INTERNATIONAL BUILDING CODE – STRUCTURAL

S1-07/08

1502.1

**FIGURE 1503.6
HAIL EXPOSURE**

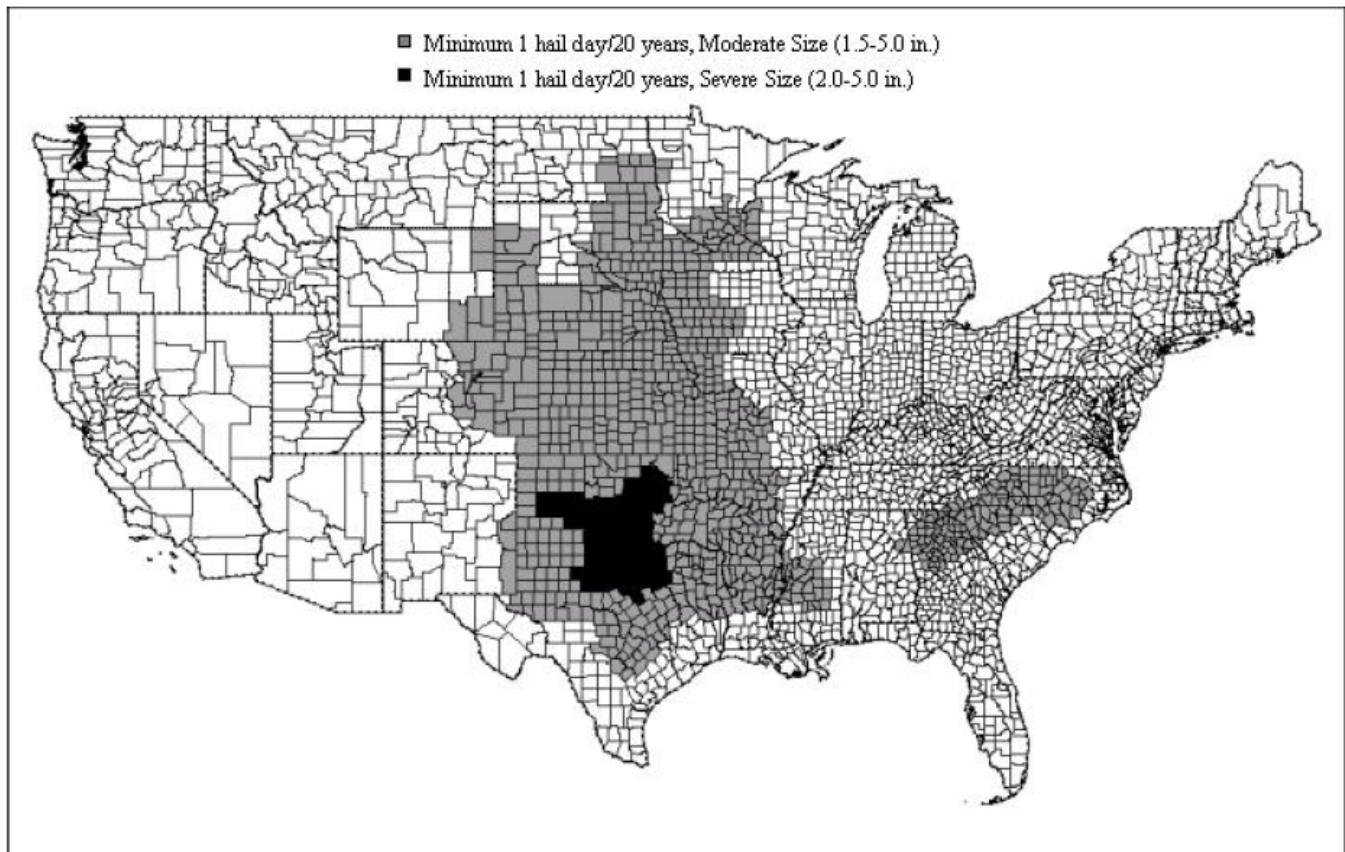
Reason: (IBC) Each year the United States experience 3,000 hail storms. Damages from these storms can run in the billions. This code change proposes to include in the Building Code a map showing moderate and severe hail prone areas. The map was developed by Haag Engineering utilizing data obtained from the National Climate Data Center (www.ncdc.noaa.gov/oa/ncdc.html). Data was compiled from the past twenty years, and included airport data as well as eye witness accounts. A computer program was created to analyze and map the data. The program considered that reports in rural areas were less than those in more populous areas, otherwise the data would conclude that it hailed more in populous areas versus sparsely populated areas. The program also considered that eyewitness accounts tend to overestimate the size of the hail. These considerations, plus others, were used to provide a conservative interpretation of the data. Areas shown on the map as severe hail exposure represent a risk of 1 or more hail days in 20 years with hail diameters greater than 2 inches. Areas shown as moderate risk represent a risk of 1 hail day in 20 years with hail diameters greater than 1.5 inches. It is important to note that the map is based upon **actual** meteorological data rather than modeling, such as the ASCE-7 wind map.

Also, this change requires that all existing roofing coverings be removed prior to installing new asphalt shingles in hail prone areas. The stiffness plays an important role in hail resistance. Too much flexibility in the system reduces the effectiveness of the of the system's resistance. Recovering over an existing roof system significantly reduces the impact resistance of the roof. Hailstones impacting a roof with two or more layers of asphalt shingles results in a "sponge" effect with the top layer being more susceptible to penetration by the hailstone, thus increasing the potential for water penetration under the roof covering. This sponge effect was observed and reported by the Roofing Industry Committee on Weather Issues (RICOWI) in its Hailstorm Investigation Report. The report confirmed that roofs with asphalt shingles overlaid over other roof coverings experienced damage at smaller size hail than roofs on solid decks.

**FIGURE 1503.6
HAIL EXPOSURE**

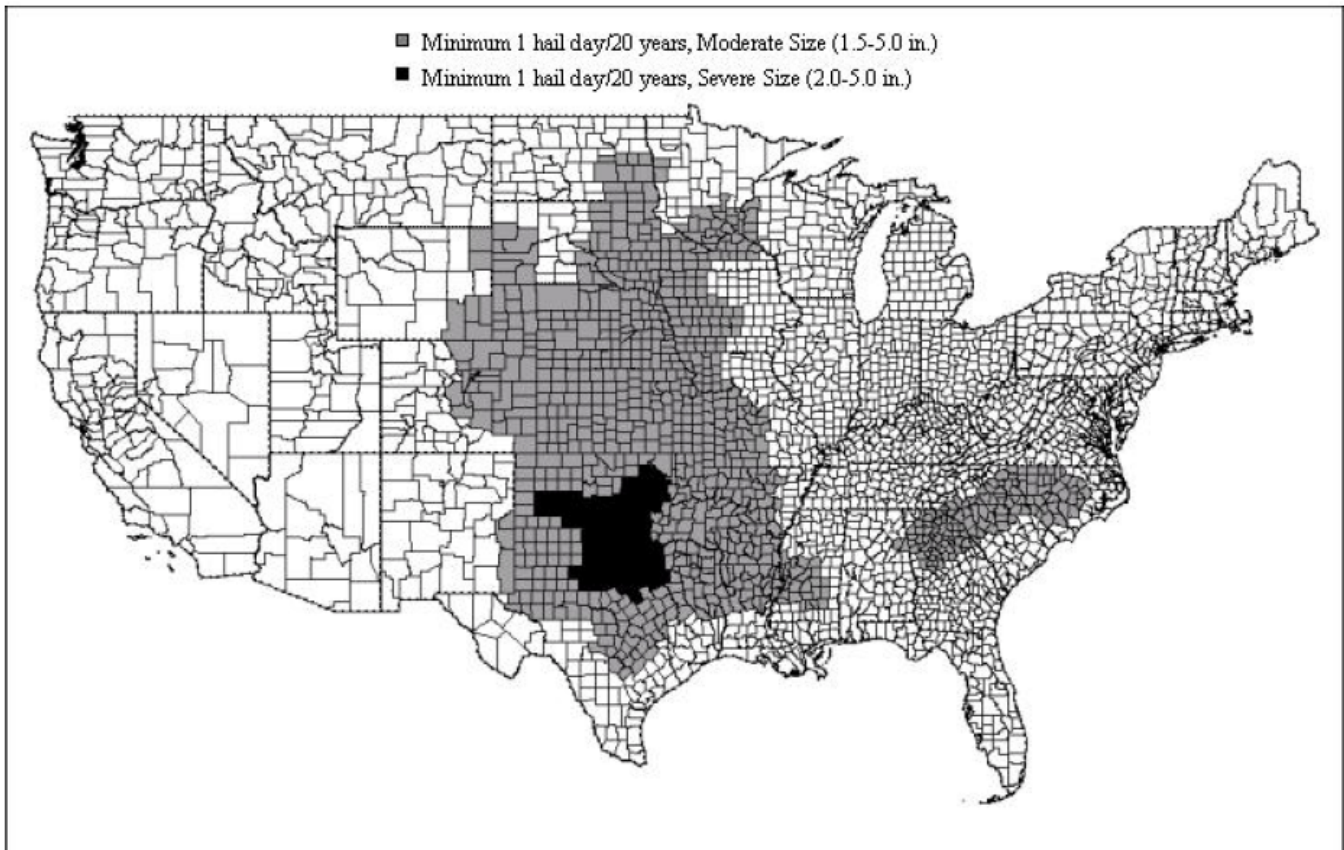
Commenter's Reason: The modification deletes the requirement for the installation of impact resistant roofing in severe hail prone areas. The proposal will add the definitions for moderate and severe hail exposure areas and add the map. This change will make the IBC consistent with the IRC.
